## Conservation Design Forum

October 16, 2017

**Re:** Barrington Area Library

Conservation Design Forum has completed a review of the documents related to the purchase and development of a portion of the Barrington Area Library's property by the Village of Barrington for the relocation of Lake Zurich Road. The documents that were reviewed include:

Figure 1: Proposed drop-off is not ideal

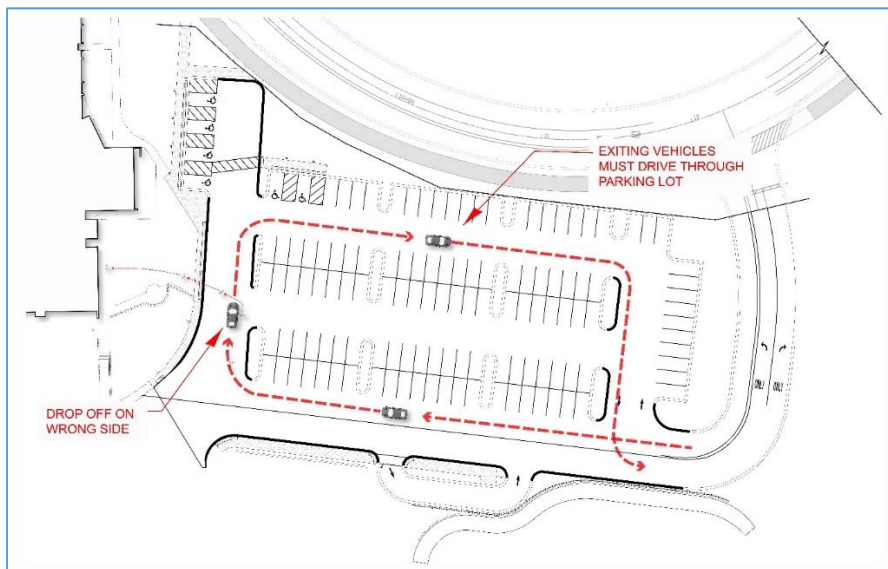
4. The arrangement of the new parking lot and access lane does not allow for a functional visitor drop-off. In the proposed design, passengers will be dropped off on the opposite side of the vehicle from the building's entry and forced to cross the circulation drive to enter the building. An alternative parking lot and drop-off arrangement could address this issue and have the added benefit of allowing drivers to exit the site without having to drive through the parking lot. The Village should work with the Library's consultant team to develop and review alternative parking lot layouts.

Figure 2: Non-conforming slopes in parking lot

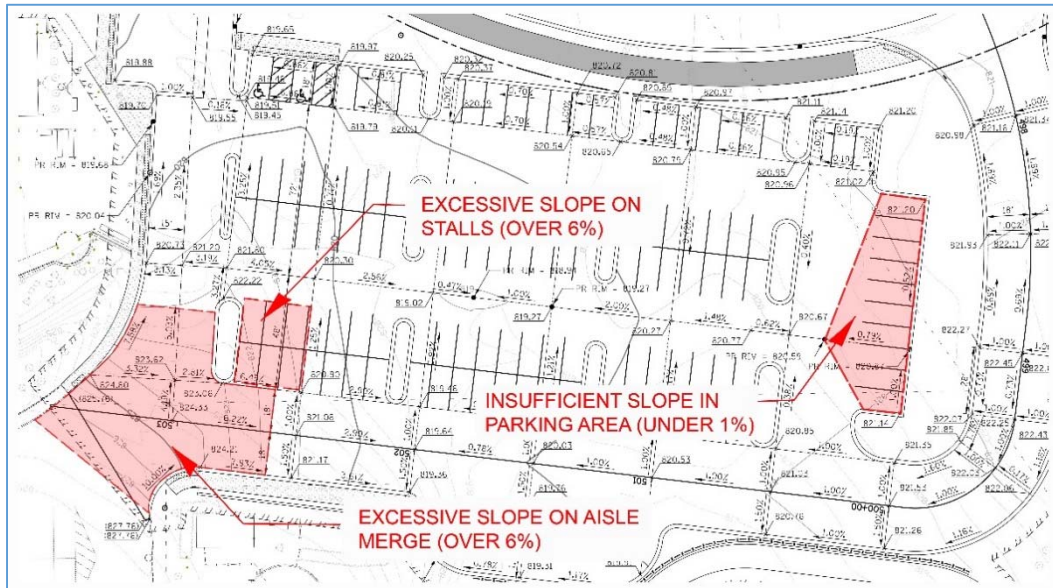
1. The design for the proposed parking lot does not meet the minimum standards required by the Village of Barrington's Off-Street Parking and Loading ordinance. Specifically:
  - a. Several parking stalls and access aisles at the south end of the new lot exceed the maximum 6% slope required in Chapter 4, part 10, section E. (see figure 2)
  - b. A large area at the north end of the parking lot is under a 1% slope which does not meet the minimum slope required in Chapter 4, part 10, section E. (see figure 2)

Figure 3: Parking Lot Curb Radii

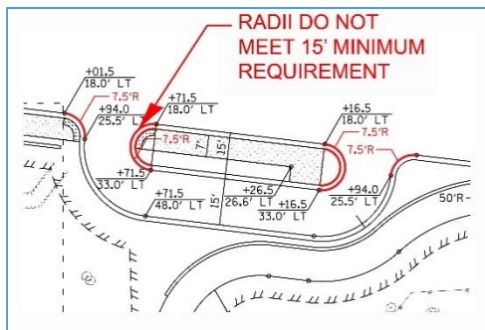
- c. The inside curb radii for the entry and exit into the book drop-off lane are only 7.5 feet which do not meet the minimum radius of 15 feet required in Chapter 4, part 10, Section B, note #6. (see figure 3)

Figure 4: Required Parking Lot Front Yard Setback

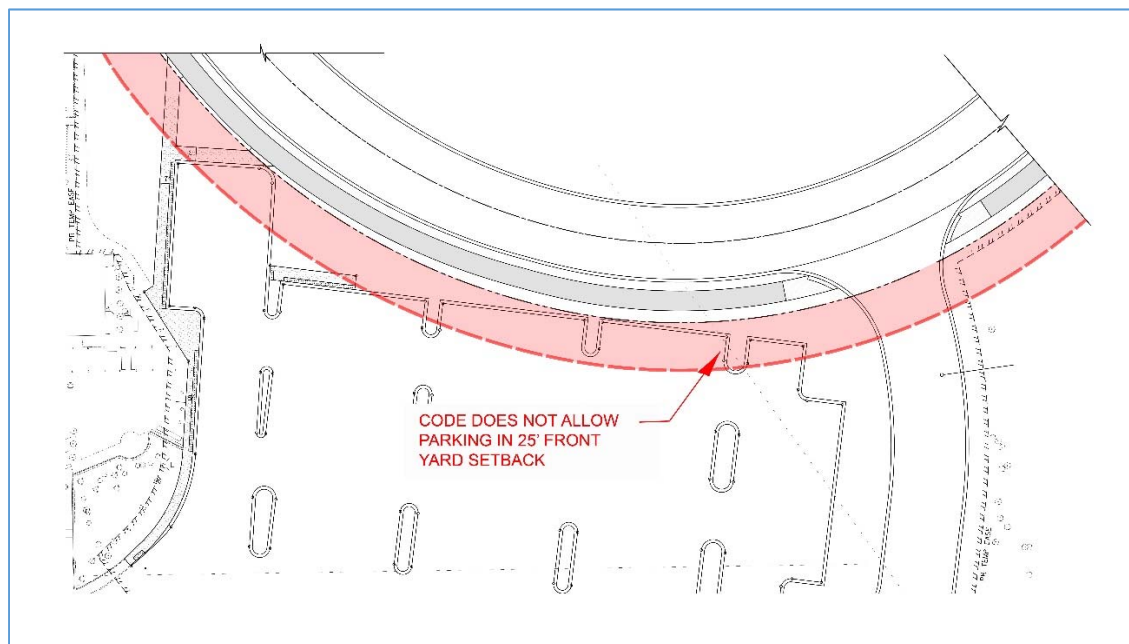
- d. The parking lot is not set back from the front yard as required in Chapter 9, part 2, section M. This ordinance requires that parking lots be located outside of the front yard which for this project would be established by the existing library building at 25 feet. (see figure 4). The setback is intended to provide room for perimeter parking lot landscaping which would screen parked cars

from the adjacent public right-of-way. This is a requirement typical of most municipal codes and is intended to preserve property values (including the value of the subject property) by screening nuisance views.

Figure 5: Internal parking lot planting islands are non-conforming

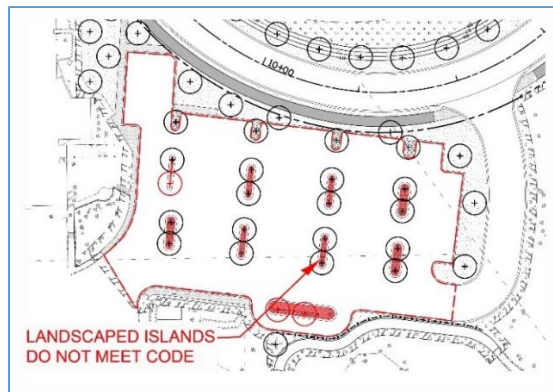
- e. The Village's ordinance requires internal planting islands with a total square footage exceeding 10% of the paved area of the lot. Each of the islands is required to be a minimum of 300 square feet and must have at least 2 shade trees and accompanying shrubs or perennial groundcovers. The proposed parking lot islands do not meet these requirements (see figure 5). The requirements are typical of most municipal codes and are intended to preserve property values (including the value of the subject property) by breaking up the monotony of paved spaces. The tree cover is also important as it shades dark pavements during the summer to reduce the urban heat island effect that produces smog.

- i. Since the proposed lot is 57,178 square feet, 5,718 square feet of planted islands are required. Only 3,574 square feet are provided.
  - ii. Two of the planted islands are smaller than 300 square feet.

- iii. Two of the islands do not contain the minimum number of trees.

Figure 6: Last stall is not fully accessible

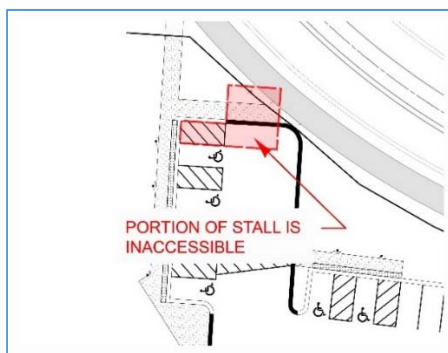
2. The proposed parking lot places the accessible stalls in a dead-end parking lot. It is important to note that drivers with permits are allowed to use both the open handicap stall and the striped access aisle for that stall. When the disabled person is the driver, they may need to park in the access aisle. Because there is no back-out aisle beyond the last handicap stall, the access aisle for this stall will not be available for parking. (see figure 6).

Figure 7: Library improvements are proposed on Village Property

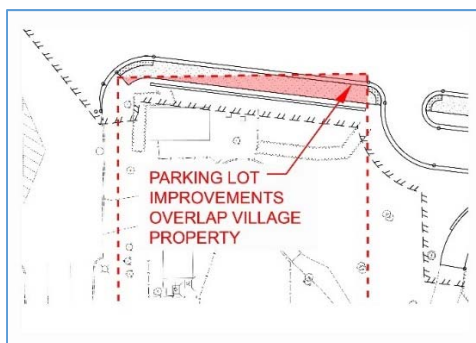
3. A portion of the parking lot drive lane and the adjacent sidewalk serving the book drop-off extend onto the Village's property at the water tower. The improvements should be moved completely onto the Library's property, or the Village should grant ownership or a permanent easement to the Library. (see figure 7)
